New Surface Parking Lot

11/10/2017

ADDENDUM #3

Landscape Addendum #3 Narrative

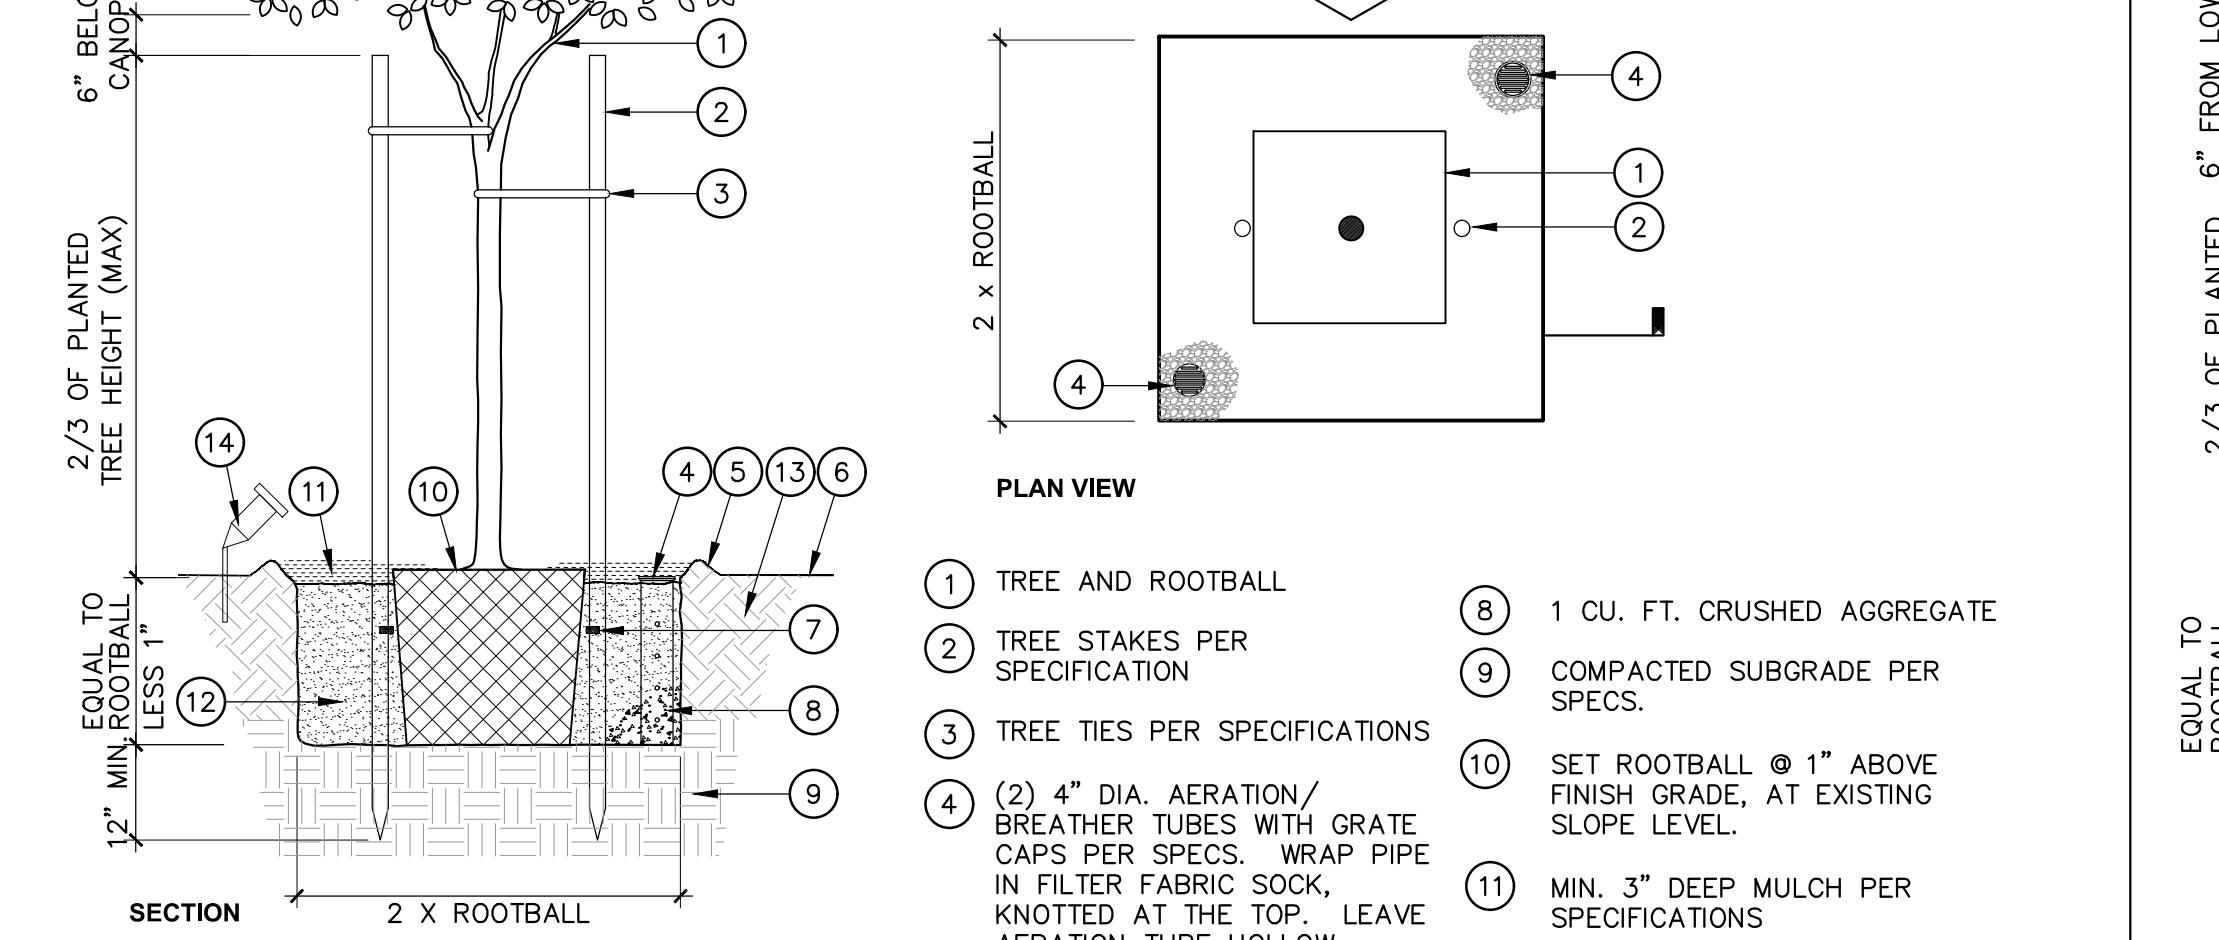
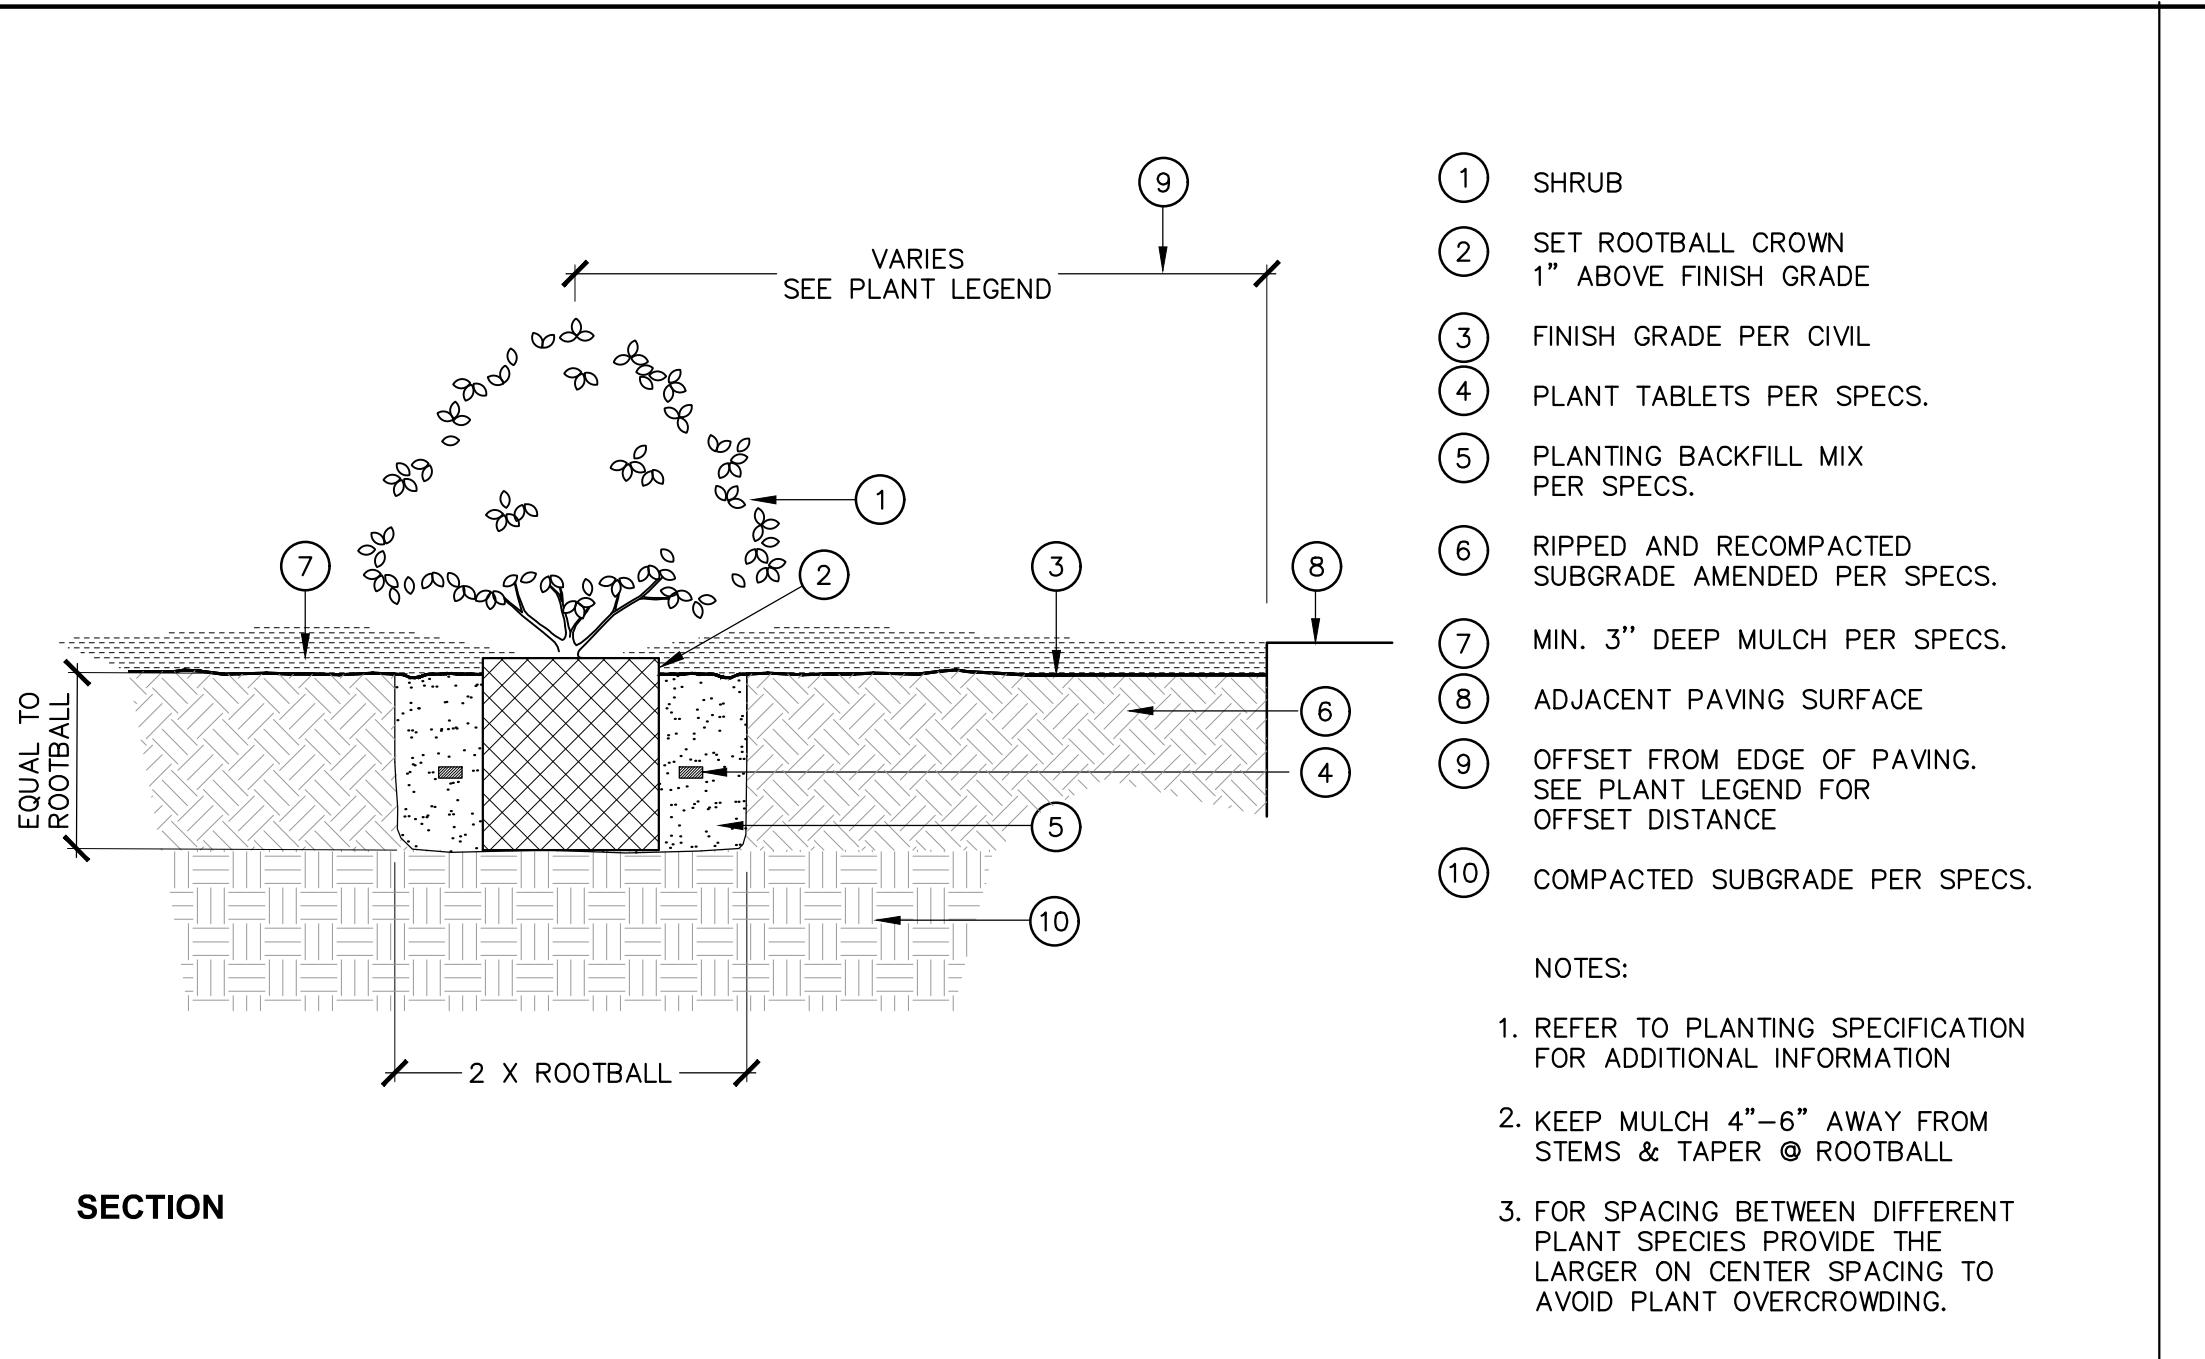
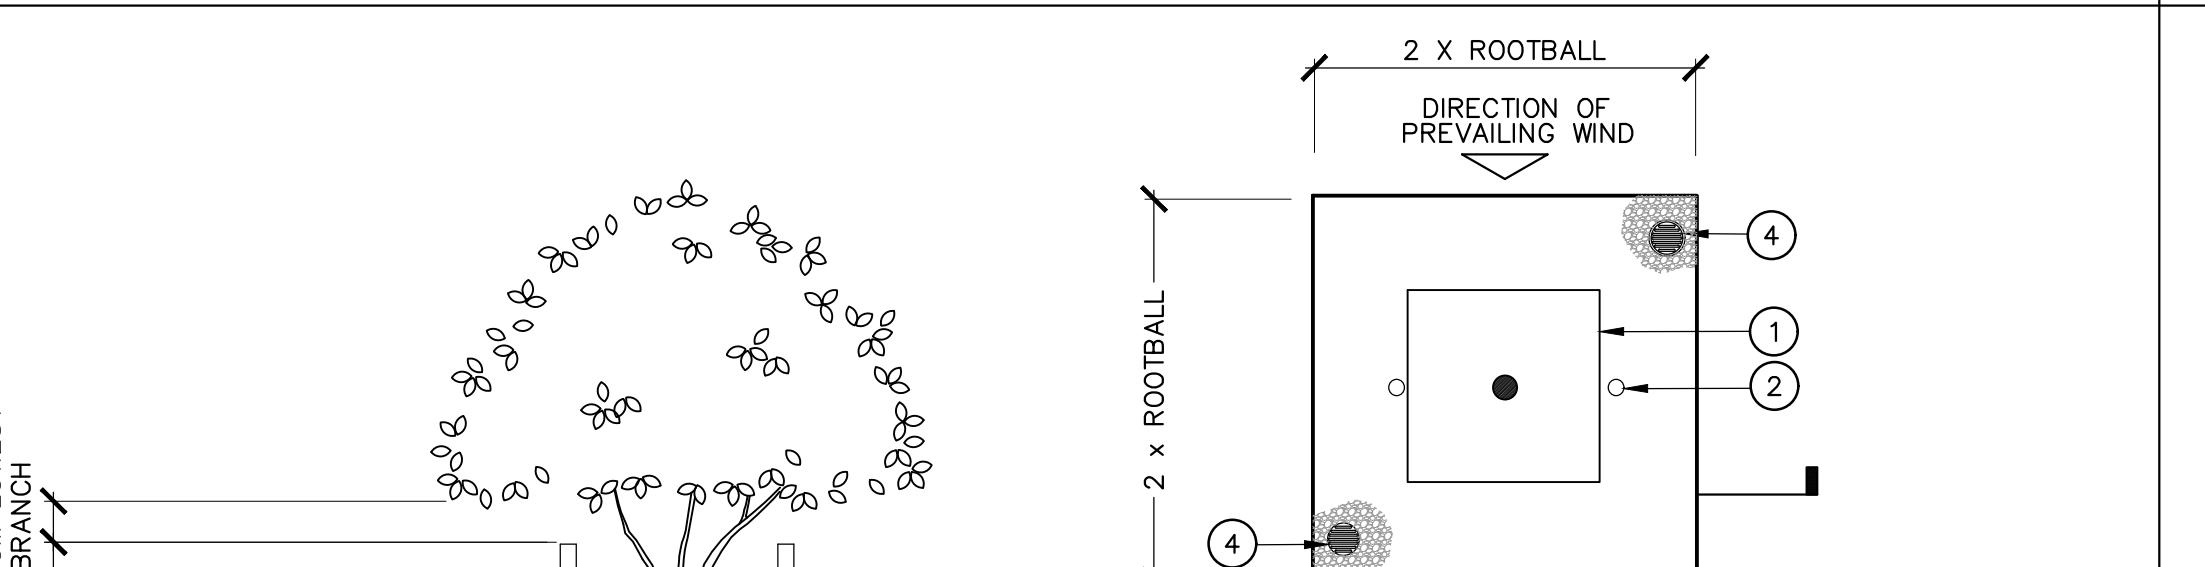
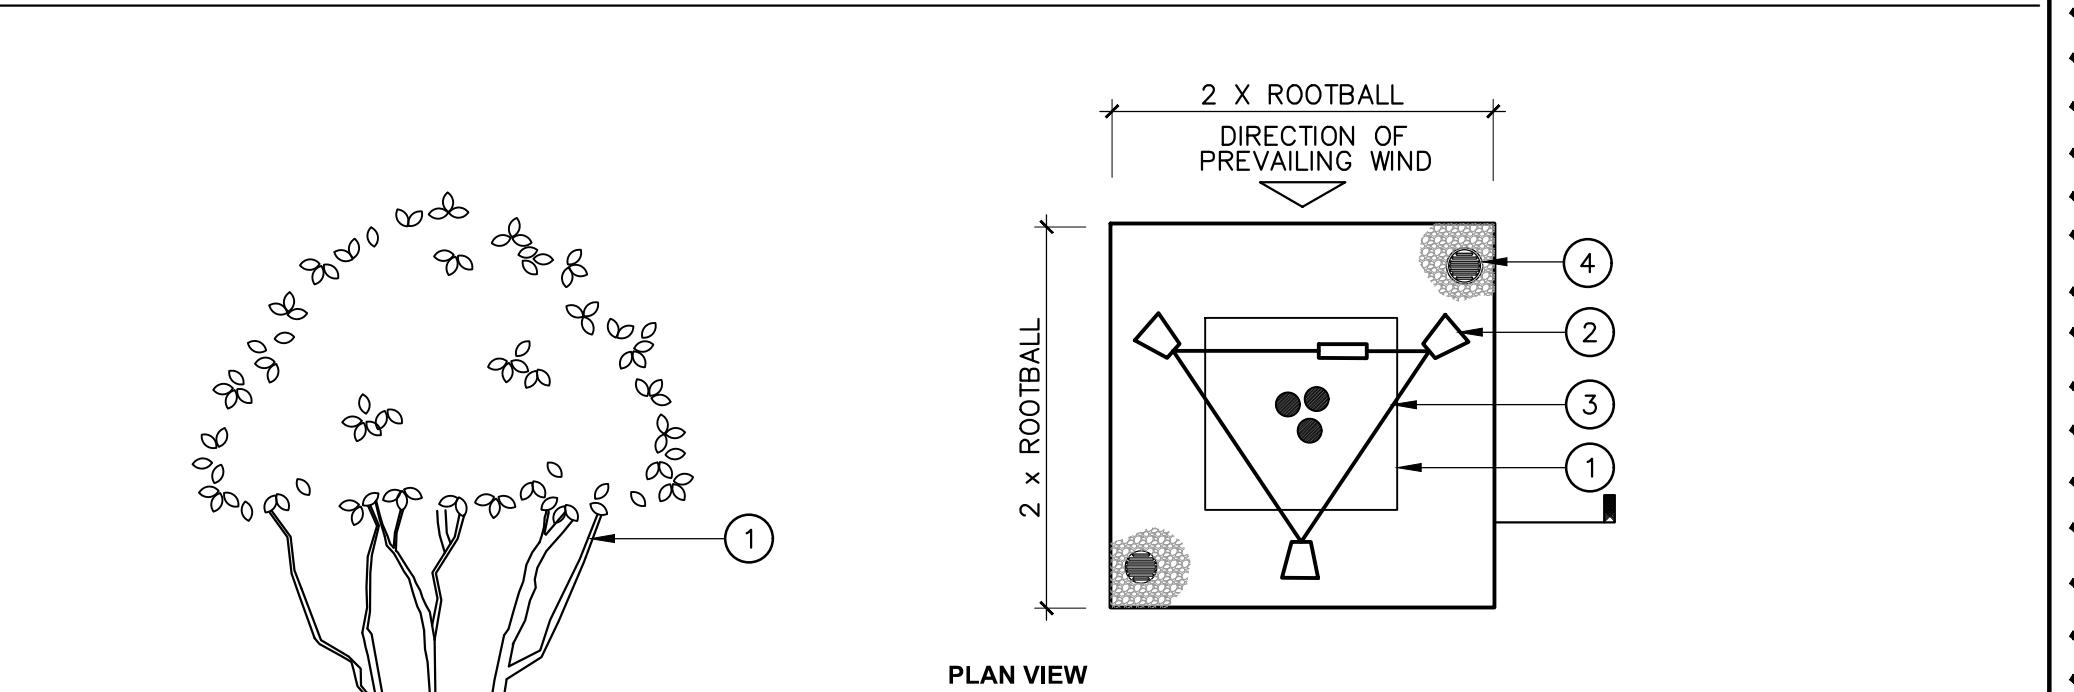
L3.03	Update Planting size, spacing and quantity. Provide complete information for hydroseed mix design.
L3.04	Add construction details for tree/shurb/groundcover.
